## HISTORIC AND DESIGN REVIEW COMMISSION

April 15, 2015

### Agenda Item No: 31

**HDRC CASE NO:** 2015-131  
**ADDRESS:** 720 N ST MARYS  
**LEGAL DESCRIPTION:** NCB 180 BLK LOT W IRRG 113.2 FT OF 18 ARB 20B  
**ZONING:** D RIO-3  
**CITY COUNCIL DIST.:** 1  
**APPLICANT:** Luna Architecture + Design  
**OWNER:** Dr. Felipe & Gloria Morales  
**TYPE OF WORK:** Exterior modifications  
**REQUEST:**

FIRST FLOOR

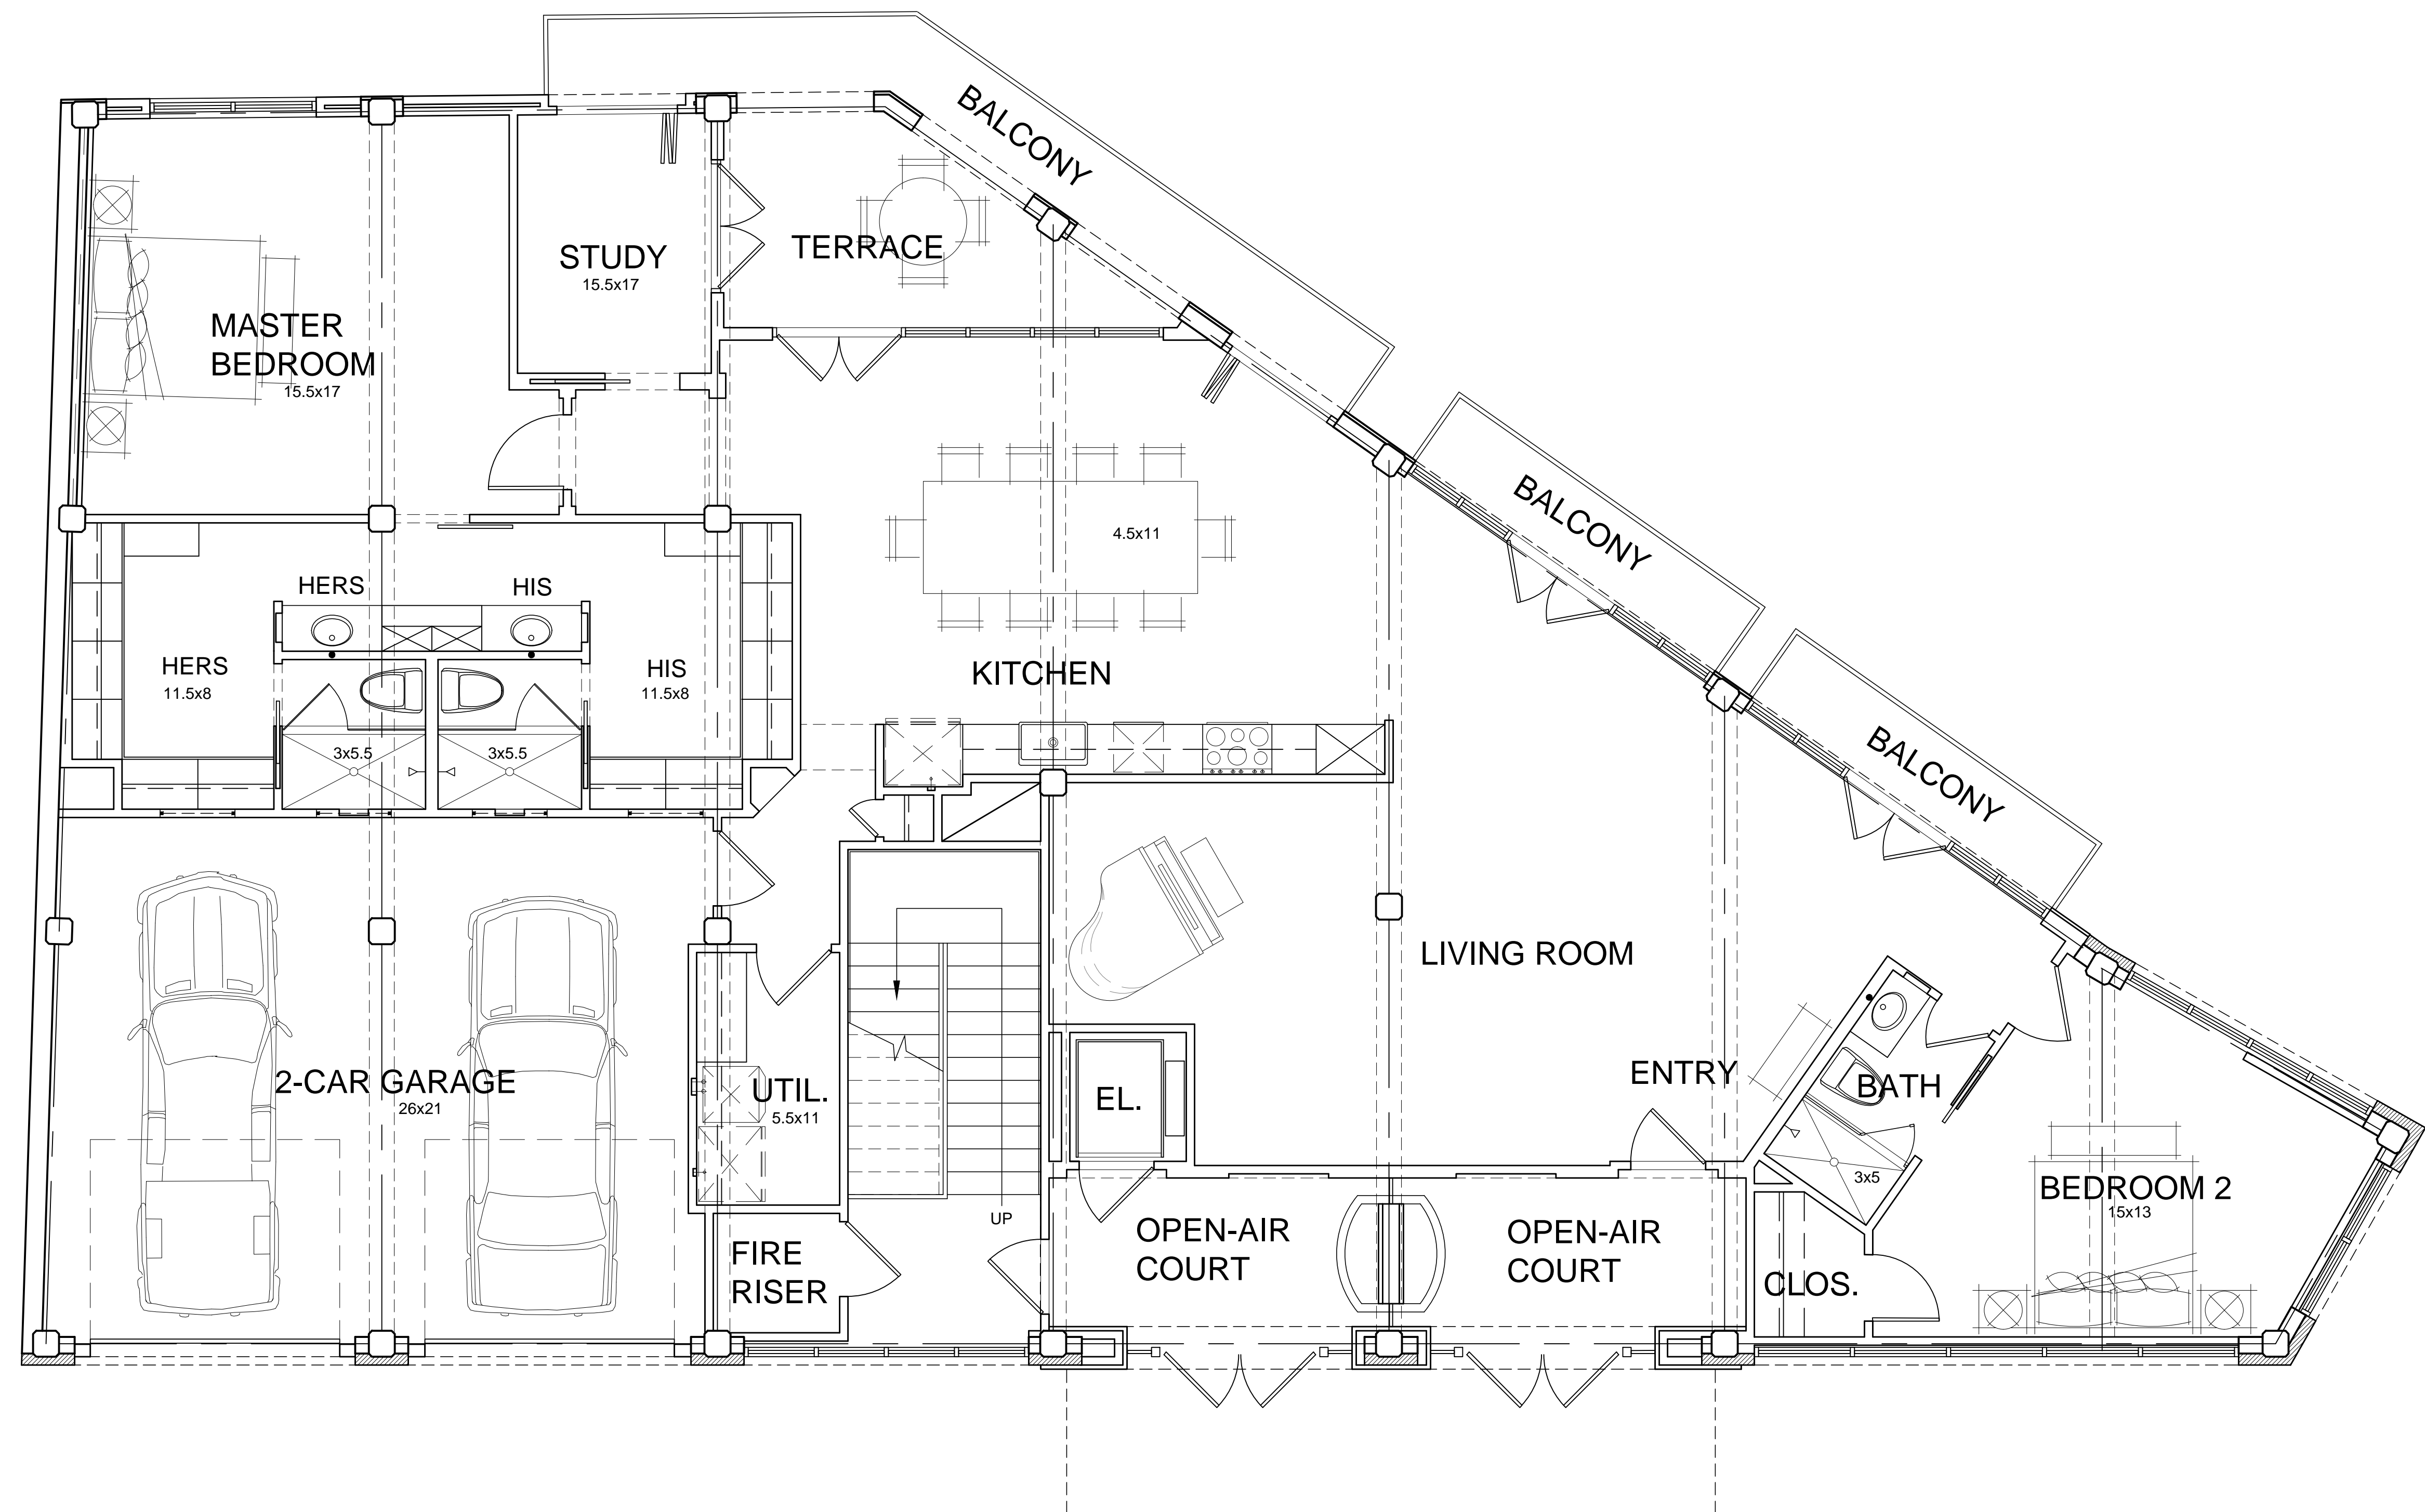
- d. Currently, the structure features an existing store front façade system. The applicant has proposed to remove the existing store front façade and to create a recessed, open-air court yard that will serve as the structure's primary entrance. Regarding entrances, the UDC states that entrances should be easy to find, be appropriately scaled and should feature a change in materials or wall plane. The applicant's proposal is consistent with the UDC Section 35-674(e)(3).

- i. The applicant has proposed to install two garage doors that will provide garage access to N St Mary's. Garage doors placed along urban corridors provide a false sense of scale, disrupt human scaled façade patterns and provide an entrance into the structure that distracts from the designed primary entrance. The proposal to install two garage doors on the N St Mary's façade is not consistent with the UDC Section 35-674(e) in regards to façade composition.

- i. That the applicant simplify the proposed railing to exclude the curved ornate design, utilize simple, square punched openings, eliminate the proposed arched openings and provide information regarding a final lighting scheme prior to receiving a Certificate of Appropriateness.

Staff does not recommend approval of items #8 and #9 based on findings h and i.

THIRD FLOOR

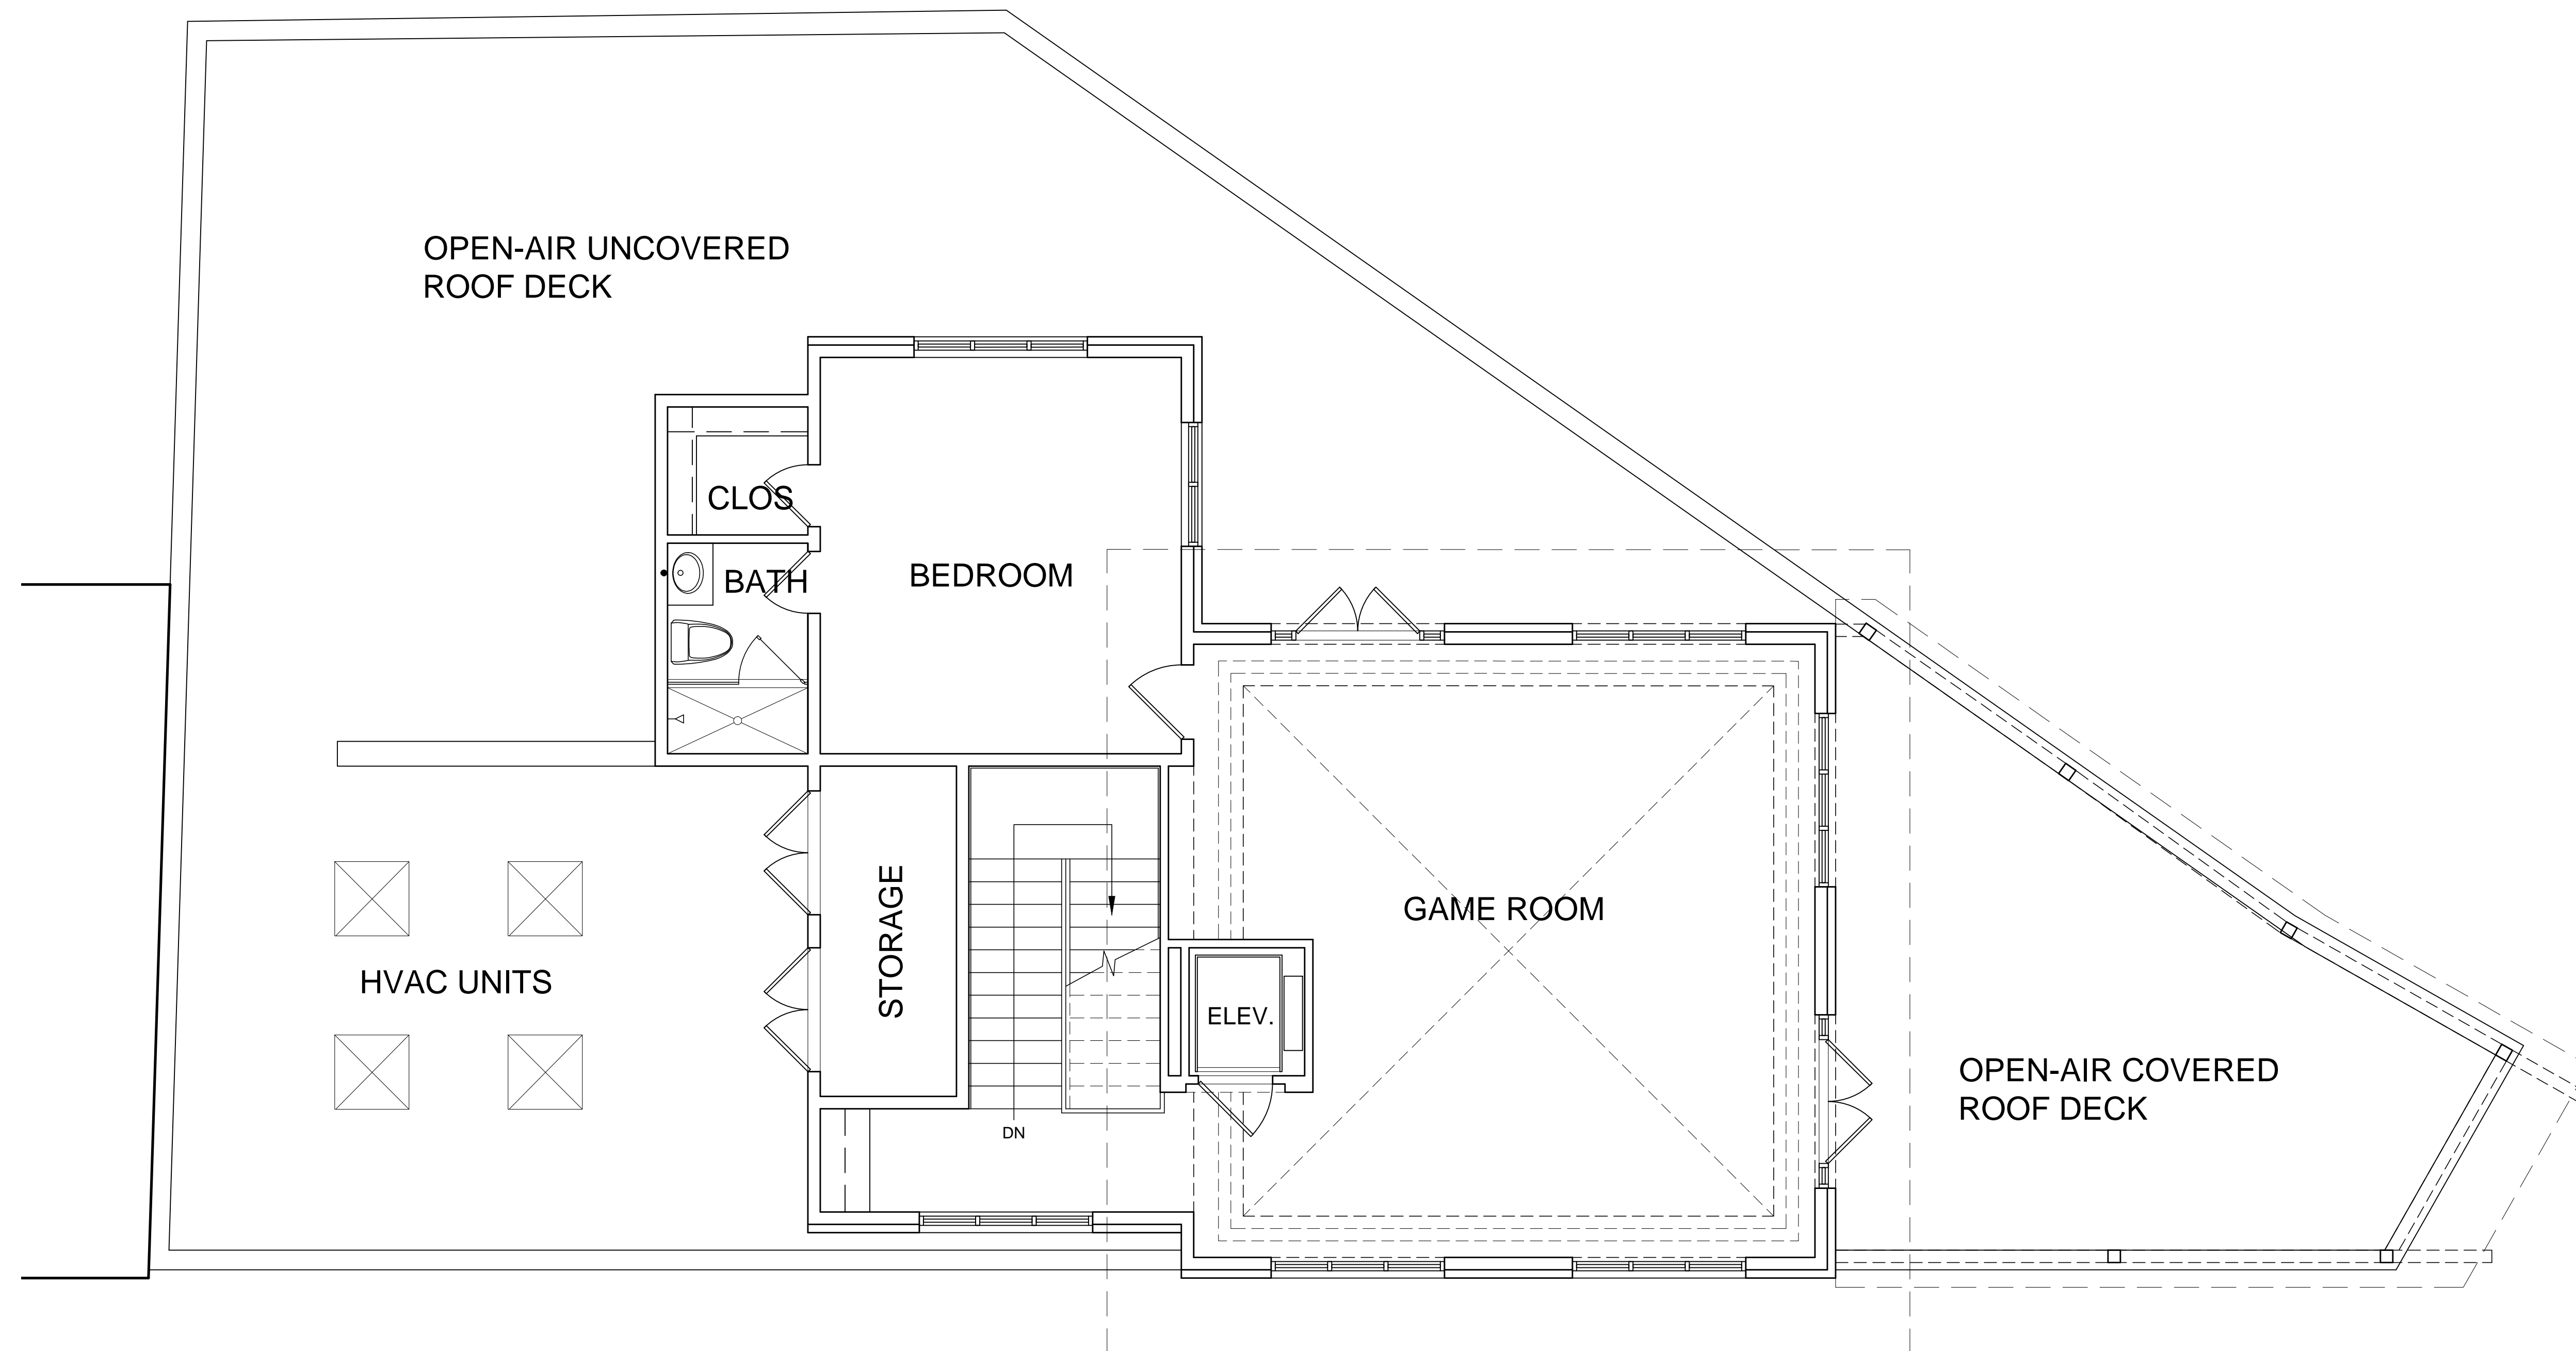
- c. The existing structure features two floors. The applicant has proposed to construct a partial third floor which would include the formation of a tower as well as a covered roof deck. The creation of the tower as well as the partial third floor form a capital and focal point at the roof line to terminate the structure. Staff finds that the creation of the third floor is appropriate, however, there are concerns with the proposed detailing. Staff finds that the third floor additions would be more appropriate with simply detailed railing, simple square punched openings, the elimination of stucco arches and simplistic metal ornamentation.

- g. The applicant has proposed to install two open-air terraces on the river façade, one on the first level and one above it on the third level. The footprint of the structure will not change. The proposal to install the open-air terraces creates depth and continues to provide a visual reference for human scale. This is consistent with the UDC Section 35-674(b).
